Southern Nuclear Operating Company
Vogtle Electric Generating Plant Units 3 and 4
Request for License Amendment and Exemption:
Power Operated Relief Valve (PORV) Noise Mitigation (LAR-18-021)

Enclosure 1

Power Operated Relief Valve (PORV) Noise Mitigation

(LAR-18-021)

**Figure 2.2.4-1 (Sheet 1 of 3)
Steam Generator System**

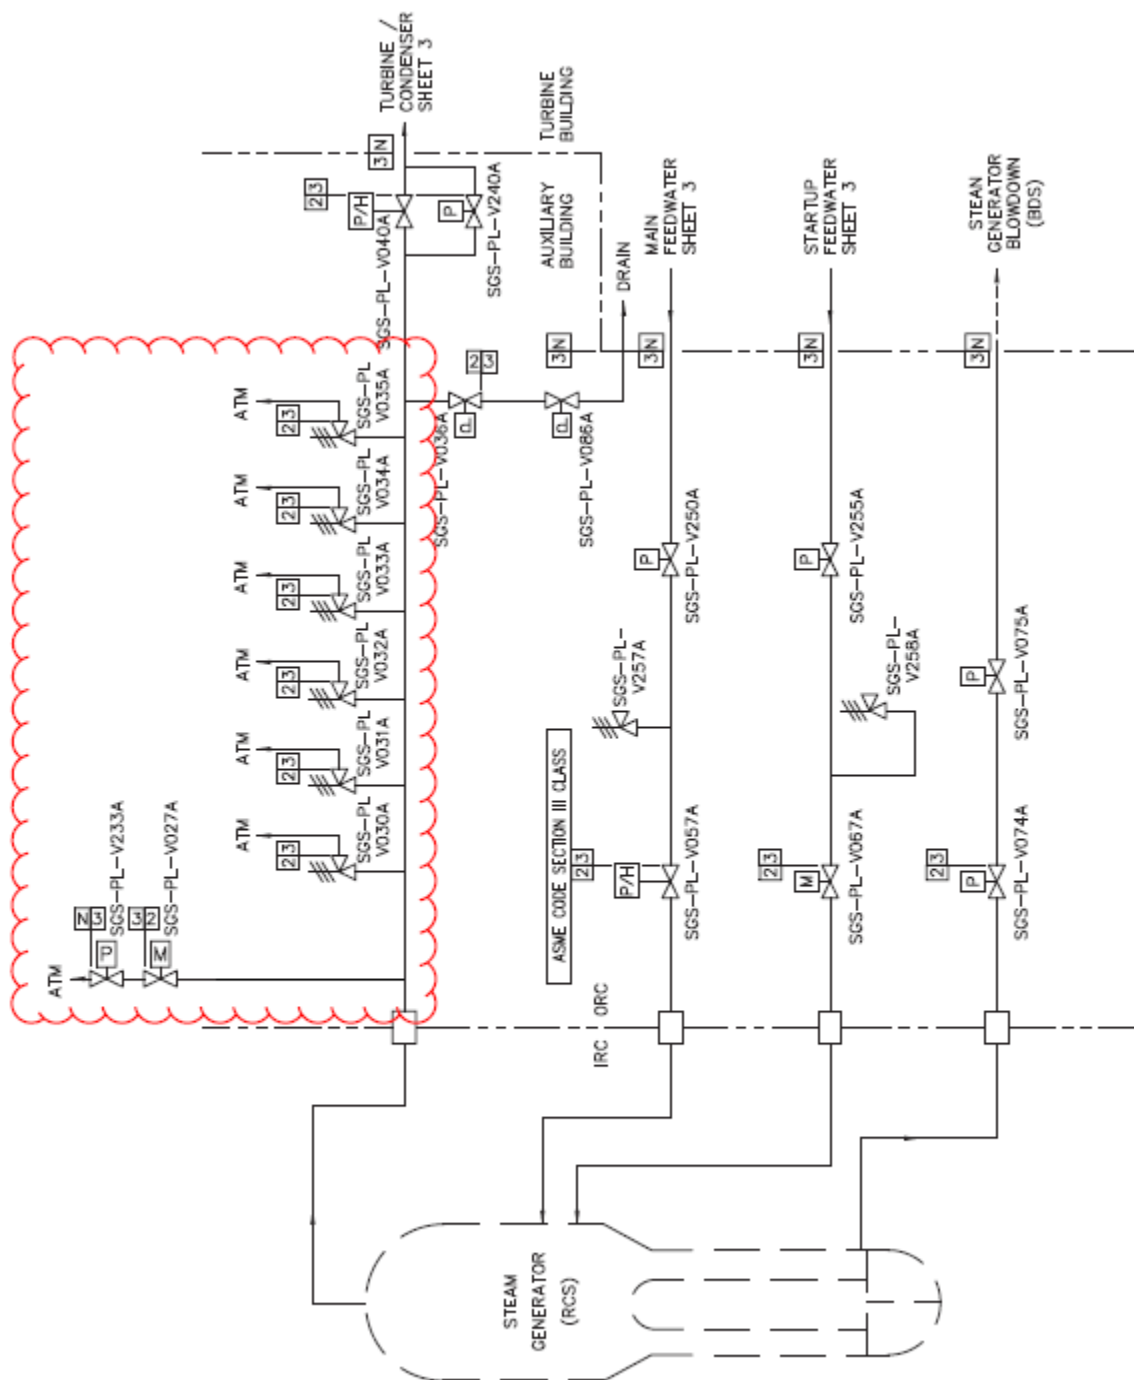
Revise COL Appendix C (and corresponding plant-specific Tier 1) Figure 2.2.4-1, sheet 1 to relocate the branch line to the PORV as shown below:

**Figure 2.2.4-1 (Sheet 2 of 3)
Steam Generator System**

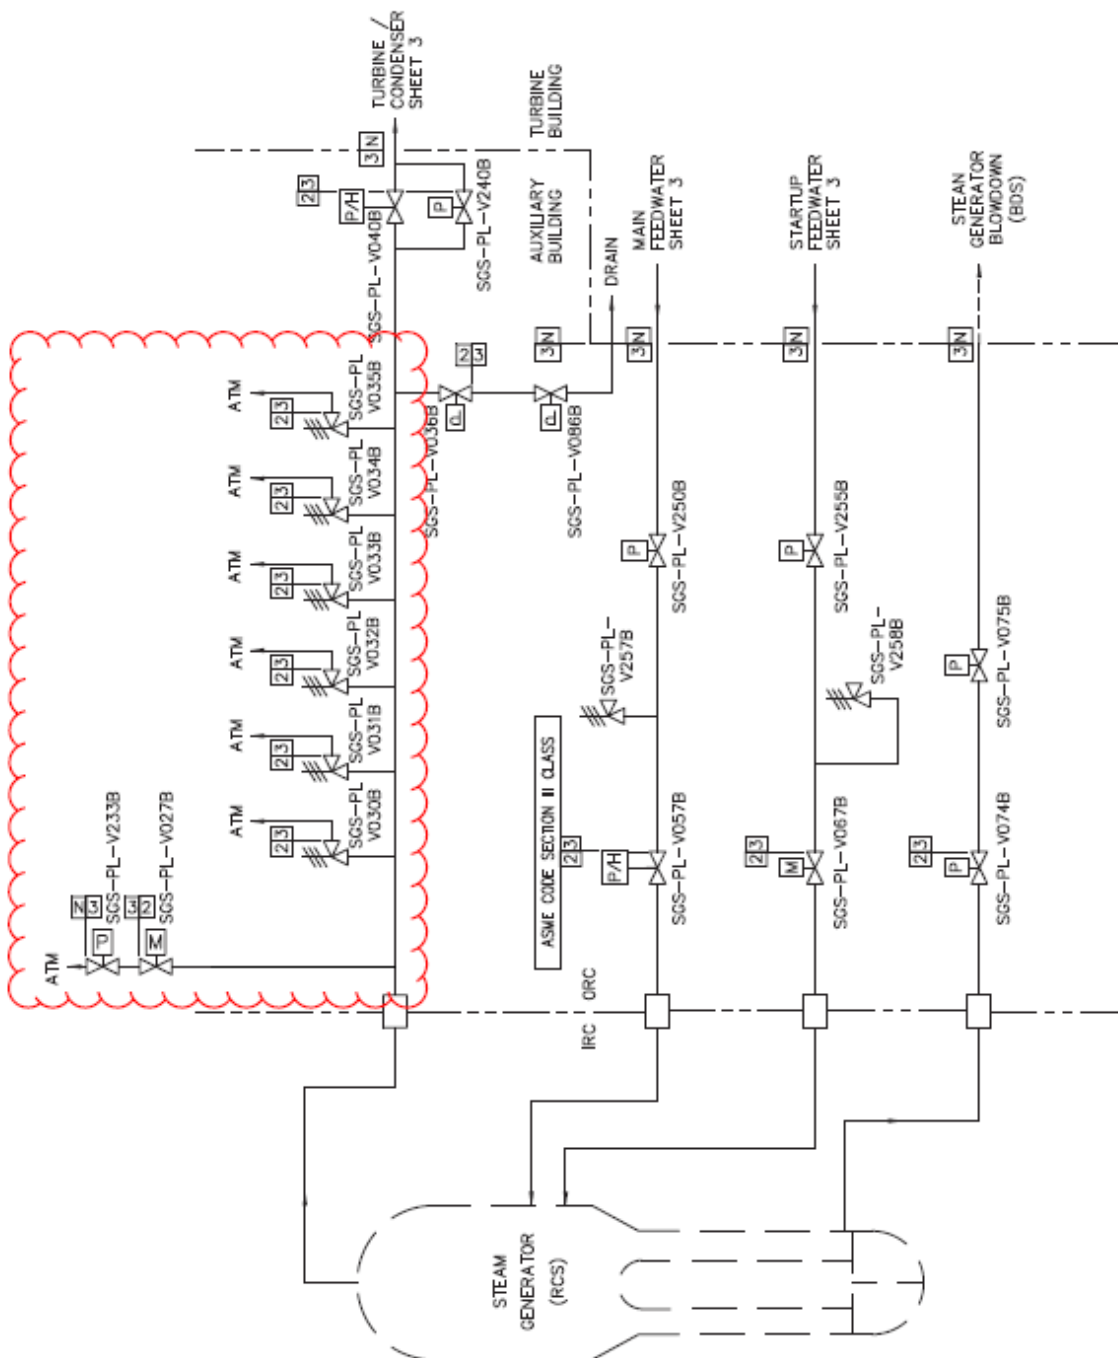
Revise COL Appendix C (and corresponding plant-specific Tier 1) Figure 2.2.4-1, sheet 2 to relocate the branch line to the PORV as shown below:

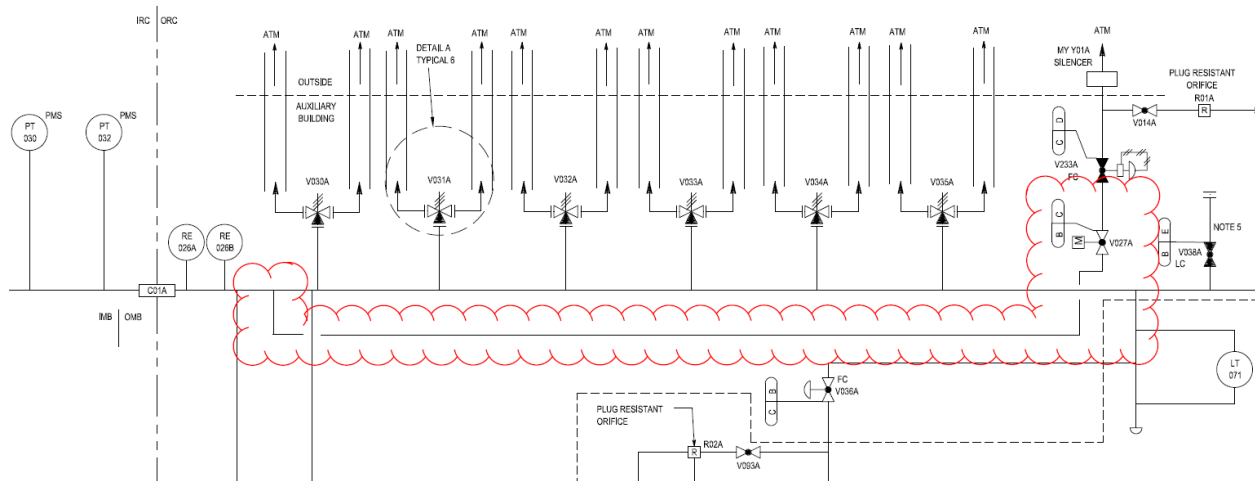
Revise UFSAR Figure 10.3.2-1 (Sheet 1), to change relocate the branch line to the PORV and PORV block valve and to change the PORV block valve from a gate valve to globe valve, as shown below:

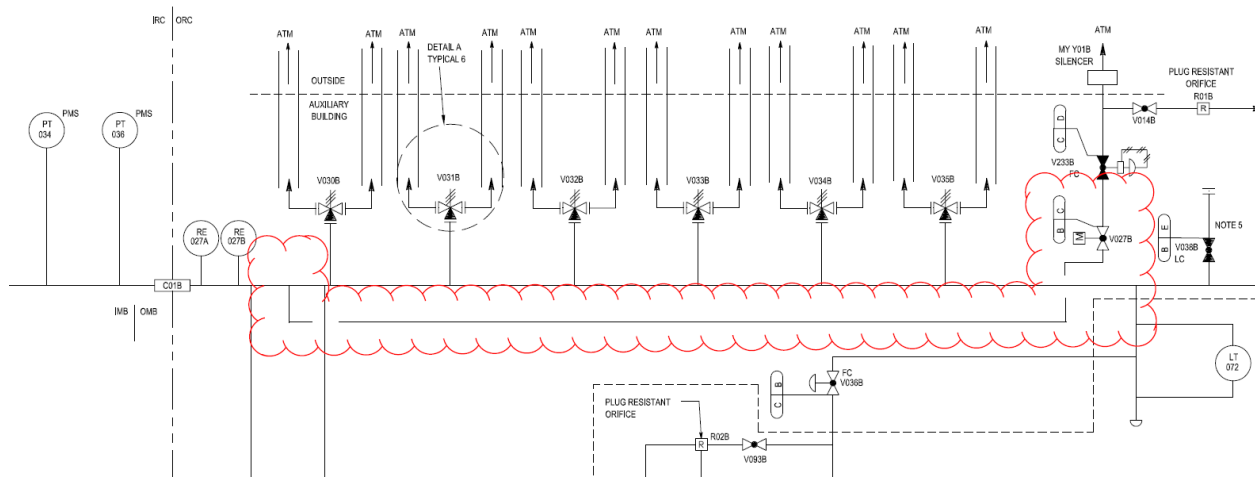
Revise UFSAR Figure 10.3.2-1 (Sheet 2), to change relocate the branch line to the PORV and PORV block valve and to change the PORV block valve from a gate valve to globe valve, as shown below:
